From: Lake , Wayne (GROUP LEADER HDC) <WayneLake@barnsley.gov.uk>
Sent: 12 September 2023 15:46
To: Hyde , James (SPATIAL PLANNING PROJECT MANAGER)
Cc: HighwaysPIngApps
Subject: FW: 2022/0115 - Land north of Shaw Lane, Carlton, Barnsley, S71 3HH

Re: 2022/0115 - Residential development of up to 215 dwellings with associated car parking/garages, landscaping, public open space including both equipped and non-equipped areas of play, SUDS and drainage, with details of a new vehicular access onto Shaw Lane (Outline with all matters reserved apart from means of access)

Transport Assessment

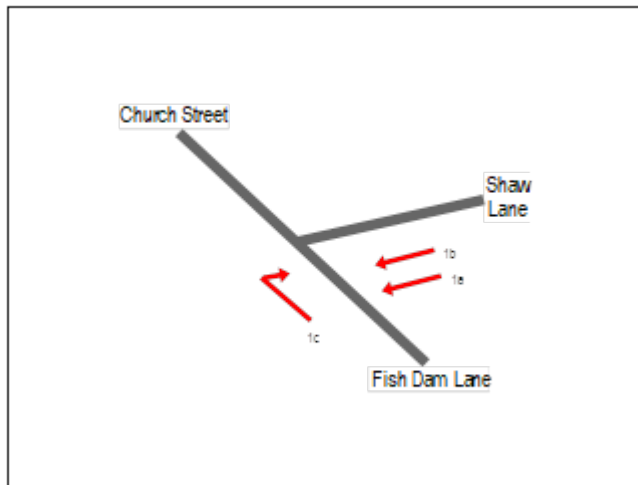
3.3 – On what basis was the study area defined? This would have been agreed as part of the scoping exercise. Current adopted supplementary planning guidance provides the underlying thresholds of assessment. This includes any development generating 30 or more two-way vehicles movements in any hour and/or any development generating 100 or more two-way vehicle movements per day. Where there are no firm threshold figures within current TAG guidance for practitioners and appraisers, current policy conforms to the now withdrawn Department for Transport document Guidance on Transport Assessment. This is not purely used to determine the need for a transport assessment but should also be considered as the appropriate metric for determining network impact and therefore the need for individual junction assessment with the TA submission. Please clarify.

Clarification provided and accepted
